# Verified Carbon Standard

## BAMBOO PLANTATIONS BY FARMERS AND COMMUNITY IN THE COUNTRY

<b>Report ID</b>	CCIPL2645/VCS/VAL-VER/BPFC/20250303
<b>Project Title</b>	Bamboo plantations by farmers and community in the country
<b>Project ID</b>	3570
<b>Verification period</b>	09 -July-2019 to 16 - December-2024
<b>Crediting period</b>	09 -July-2019 to 08 -July-2049
<b>Original date of issue</b>	27-June-2025
<b>Most recent date of issue</b>	26-November-2025
<b>Version</b>	2.0
<b>VCS Standard Version</b>	4.7
<b>Client</b>	Infinite Environmental Solutions Limited
<b>Prepared by</b>	Carbon Check (India) Private Limited
<b>Approved by</b>	Amit Anand, CEO
<b>Work carried out by</b>	Chiluveri Murari - Team Leader/Technical expert Pranav Redkar- Trainee Assessor

Figure 1: Note that the farm boundaries do not follow any physical boundary, but were apparently made just under the image.

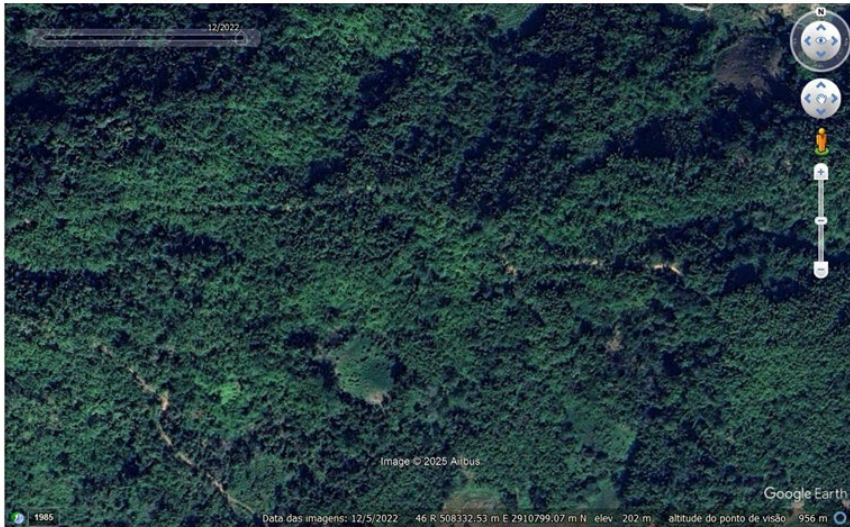
3. As described in the VCS Standard, item “3.11.2 The spatial extent of the project shall be clearly specified...”, which is not evident when analysing the KML file of the farms. The boundaries of the farms appear to have been “drawn” on the image, with no clear boundaries in the field. This situation can generate several types of conflicts and make verification and future monitoring difficult. If there were well-defined physical boundaries (fences, rivers, roads, etc.) between the properties, there would be no empty spaces between them, as can be seen in the figures below.

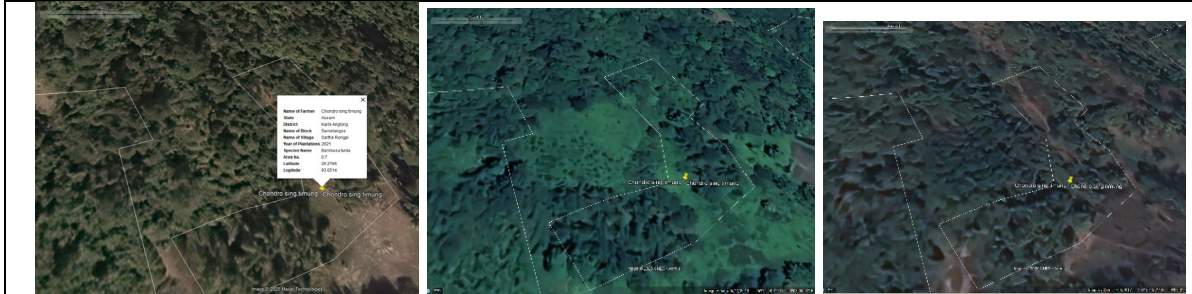
- Plot "Dibising kramsa"- existing vegetation found in 2013-2018 prior the project start date. PP shall clarify.

Plot: Chondro sing timung (Sarthe Rongpi village, Samelangso block)

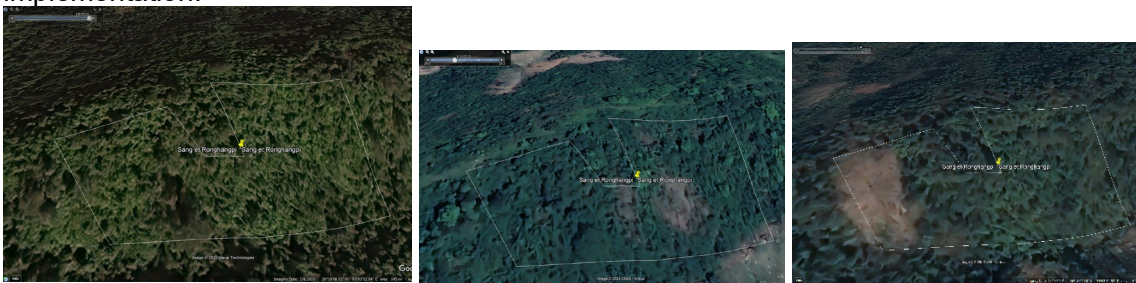
Remark: Vegetation was observed during the period of 10 years preceding the project implementation.

Plot: Longki Kro (Habe Kro village, Samelangso block)

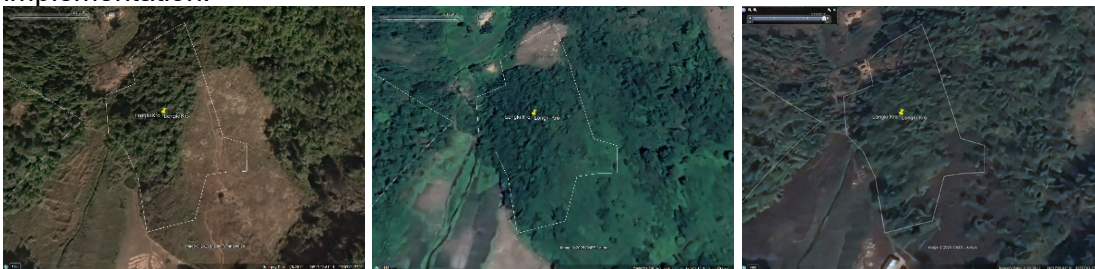
Remark: Vegetation was observed during the period of 10 years preceding the project implementation.

Plot: Men sing ronghang (Pandit taro village, Samelangso block)

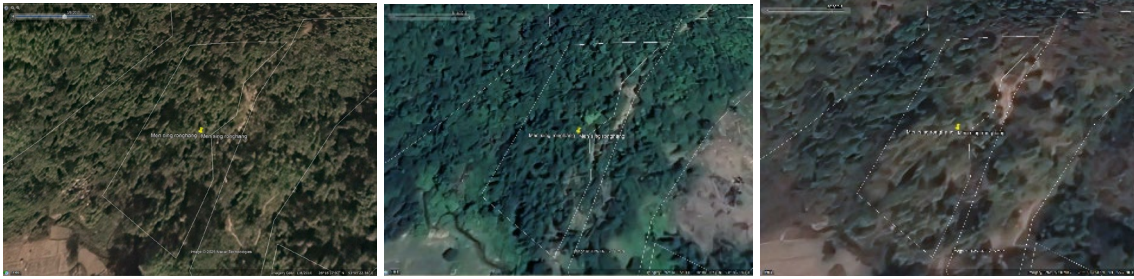
Remark: Vegetation was observed during the period of 10 years preceding the project implementation.

Plot: Babu Rongpi (Buraching Taro village, Samelangso block)

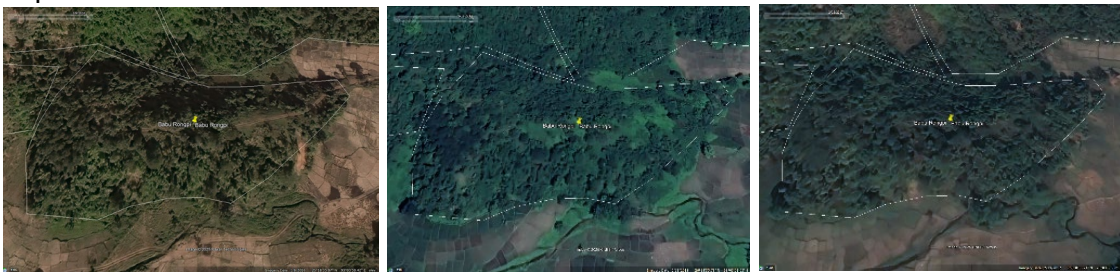
Remark: Vegetation was observed during the period of 10 years preceding the project implementation.

Plot: Manai engtipi (Thang teron village, Samelangso block)

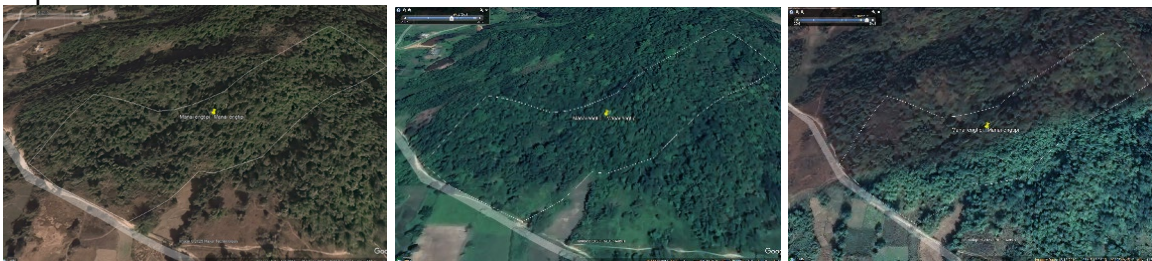
Remark: Vegetation was observed during the period of 10 years preceding the project implementation.

Plot: Monika teronpi (Thang teron village, Samelangso block)

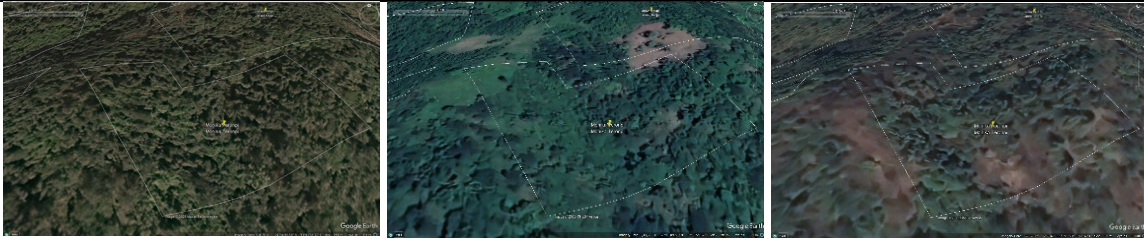
Remark: Vegetation was observed during the period of 10 years preceding the project implementation.

Plot: Sarsing Terang (Nala Ingti Gaon village, Samelangso block)

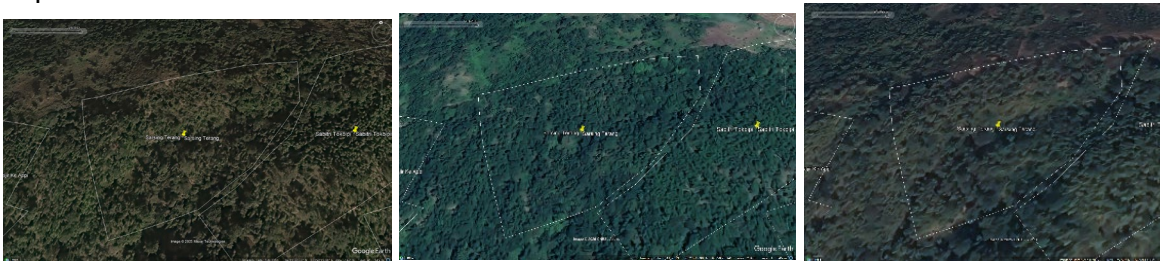
Remark: Vegetation was observed during the period of 10 years preceding the project implementation.

Plot: Mohen Teron (Matikhula Timung Gaon village, Samelangso block)

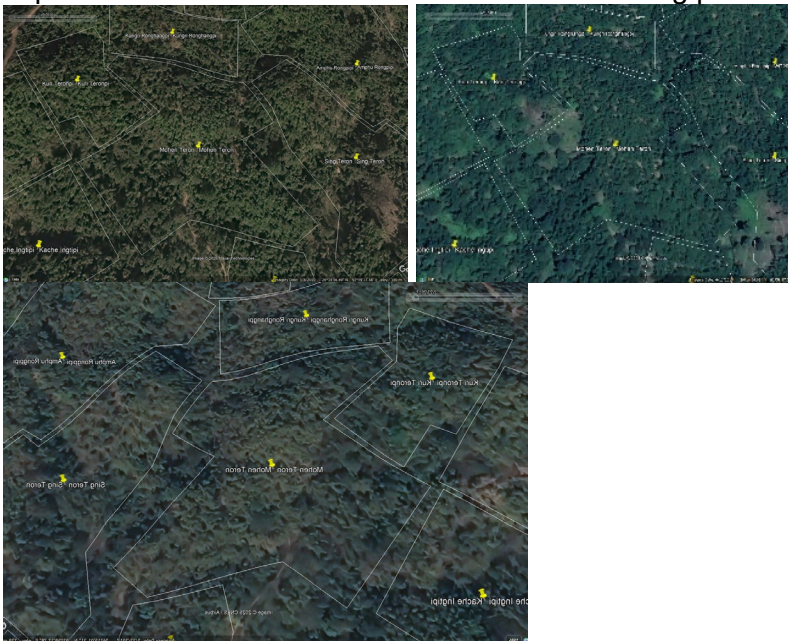
Remark: Vegetation was observed during the period of 10 years preceding the project implementation. Same was the case for the following plots:

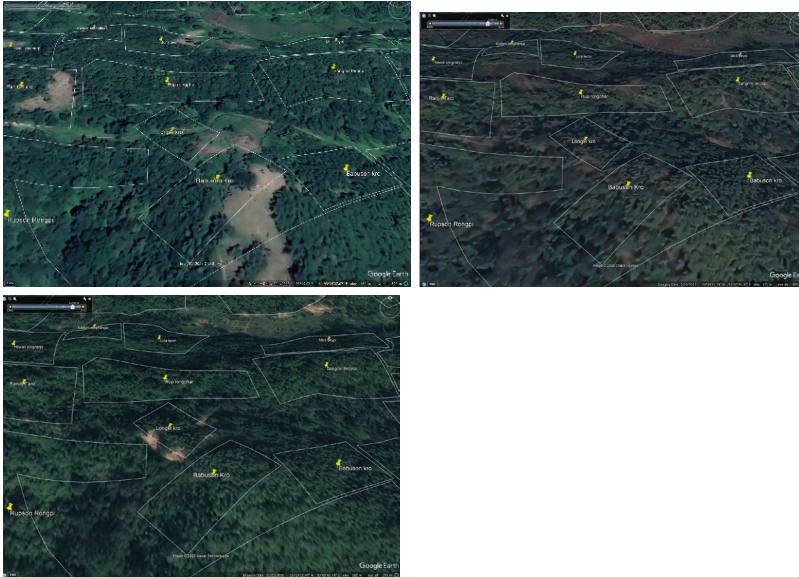
Plot “Longki kro”: existing vegetation found in 2010- 2018 prior the project start date.

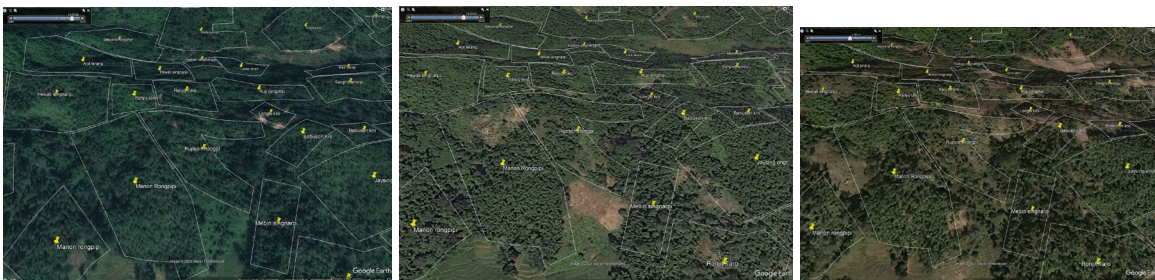
Plot “Rupasing rongpi” and also in surrounding plots: existing vegetation found across the years 2013-2018:

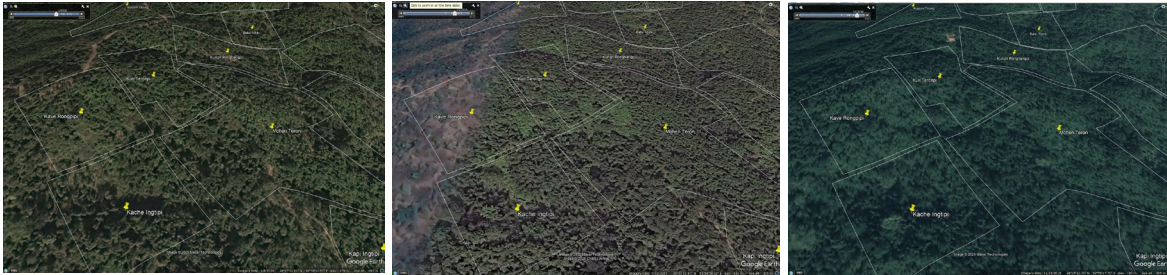
Plot- “Manon Rongpi” and also in surrounding plots: existing vegetation found across the years 2013-2018;

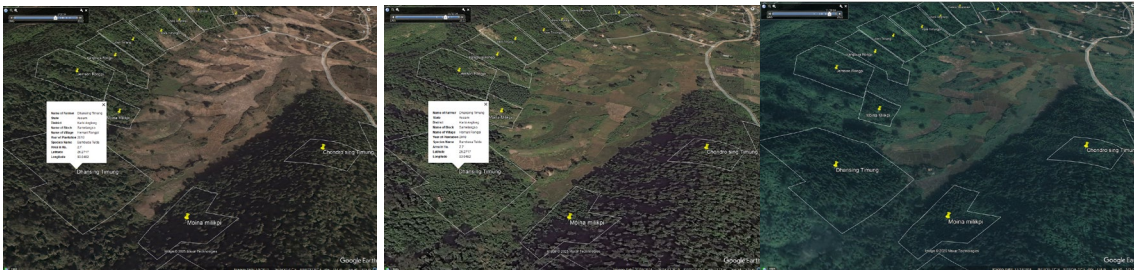
Plot- Kache Ingtipi and also in surrounding plots: existing vegetation found across the years 2010-2018.

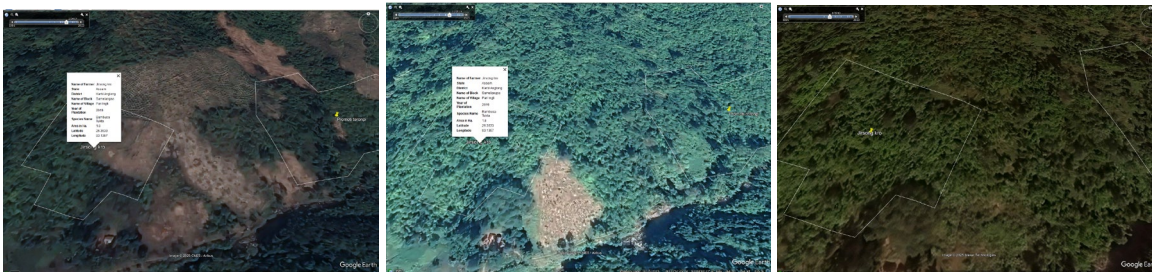
Plot-Dhansing Timung and also in surrounding plots; existing vegetation found across the years 2010-2018.

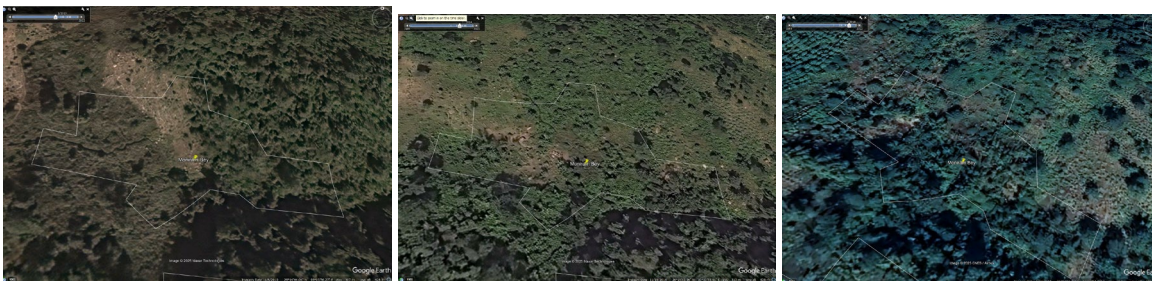
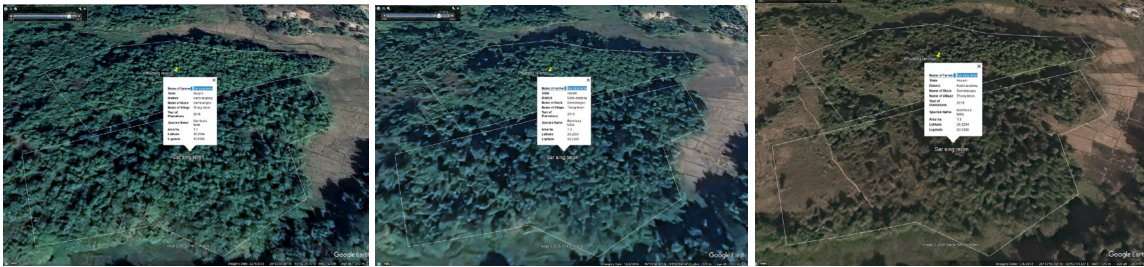
Plot-Jirsong kro and also in adjacent plots; existing vegetation found across the years 2010-2018;

Plot-Moniram Bey

Plots- Phudang teronpi and Sar sing teron- existing vegetation found across the years 2010-2018 prior the project start date.

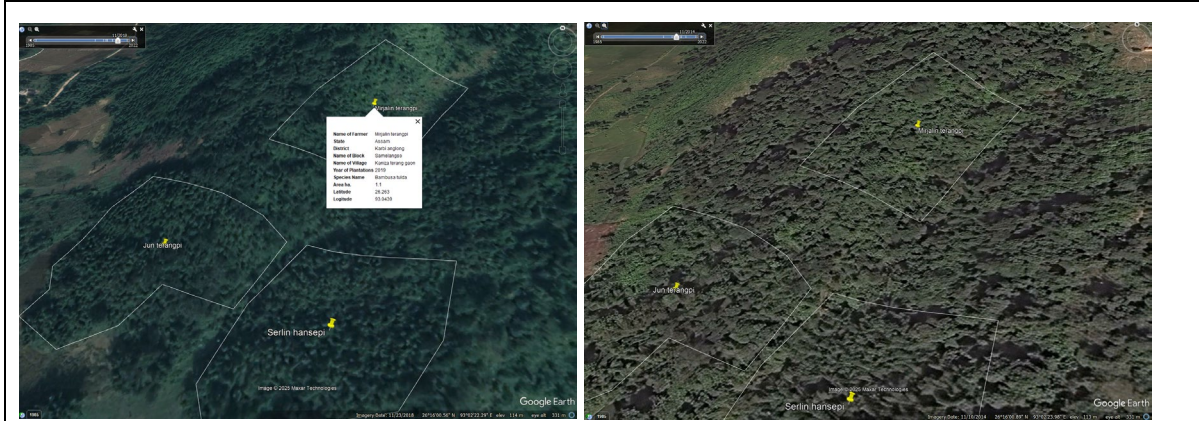
Plot-Ranjan Rongpi and in adjacent plots; existing vegetation found across the years 2010-2018

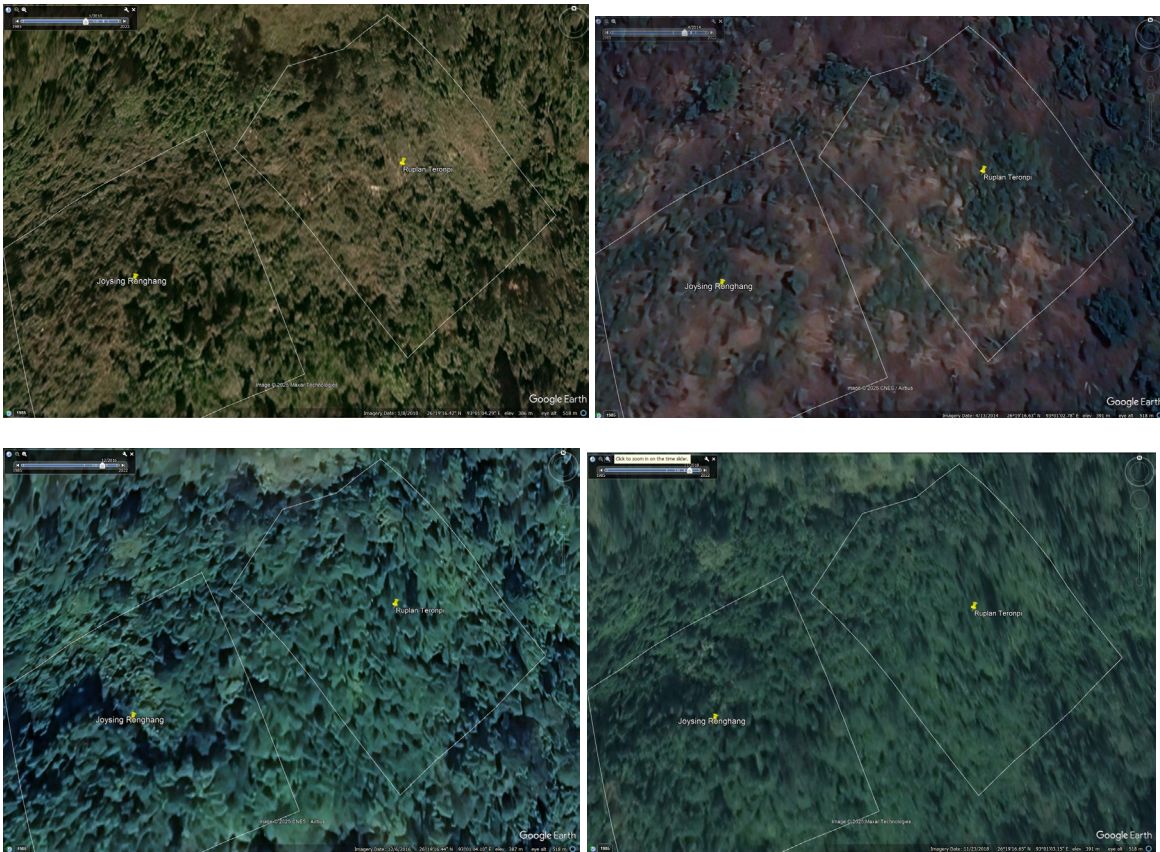
Plot- Mirjalin terangpi and adjacent plots: existing vegetation found across the years 2010-2018.

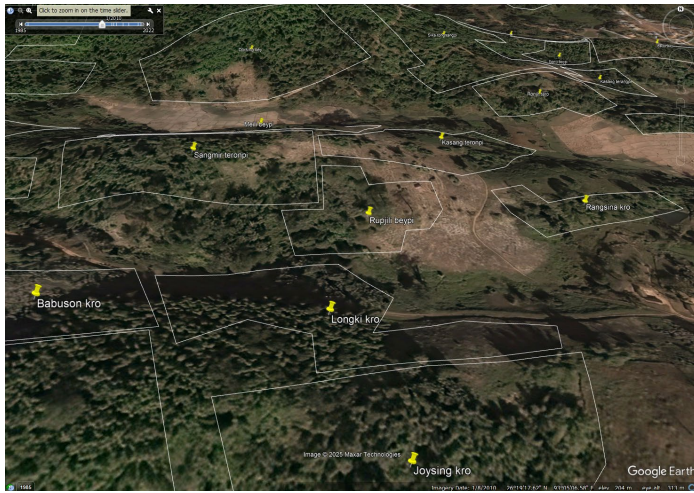
Plot- Ruplan Teronpi and adjacent plots: existing vegetation found across the years 2010-2018.

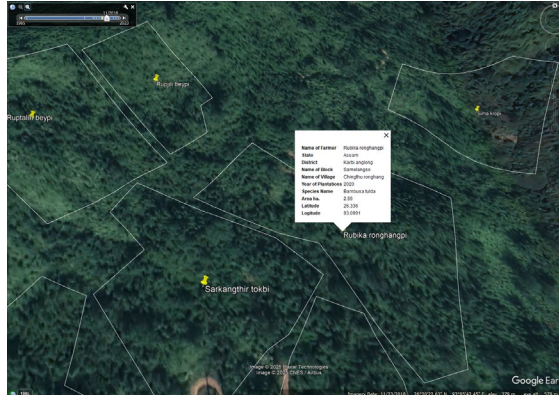
Plot- Longki kro and adjacent plots: existing vegetation found across the years 2010-2018

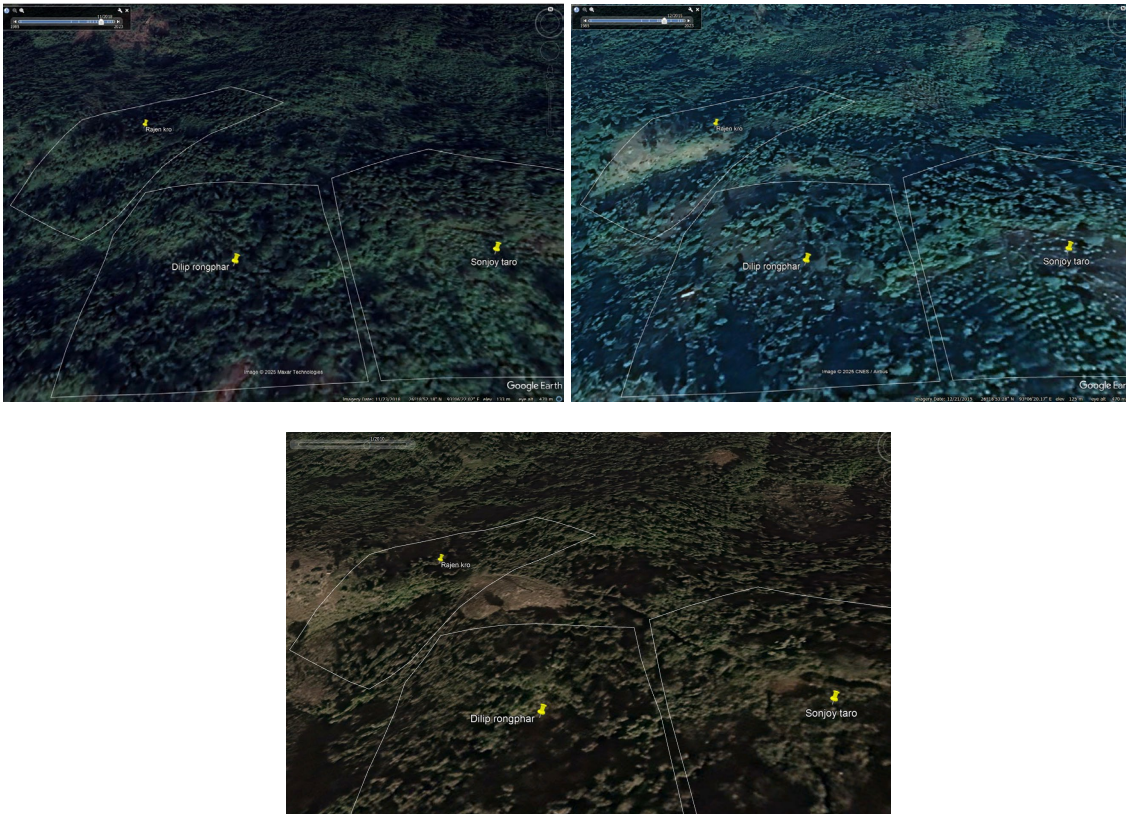
Plot- Rubika ronghangpi and adjacent plots: existing vegetation found across the years 2010-2018
